QUESTIONS AND ANSWERS

FOR: 20-04 RE-BID FOR TWO (2) 60' AERIAL TOWER UNIT MOUNTED

WITH UTILITY LINE BODY AND 1,250 LBS. MATERIAL HANDLING PACKAGE

JANUARY 29, 2020

Current GUC Configuration:

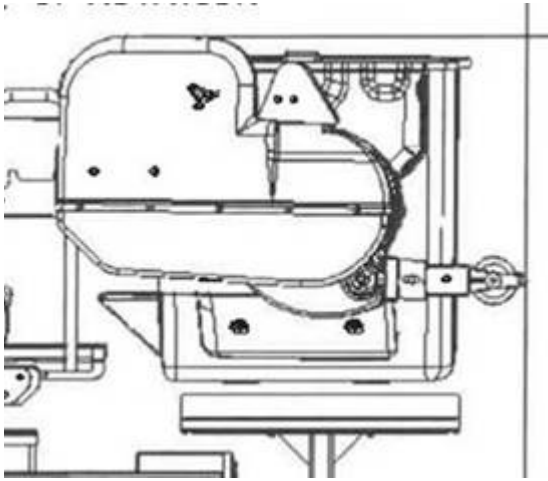
The current jib that GUC has is a manual extension/hydraulic articulation with the winch on top of the boom. A hydraulically extending and articulating jib is available but not with the winch on top of the boom as requested. Please see pictures below. Please let me know which jib package you would prefer. Thanks

The manually extended, hydraulic articulating jib with the winch on top of the boom is desired. The description will be corrected in future bid packages.

What is currently in the bid spec:

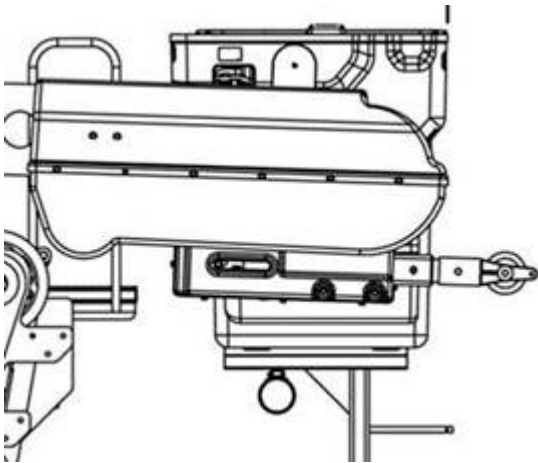
Hydraulic extended underslung jib/winch. Provide with the winch line payout over top of the jib.
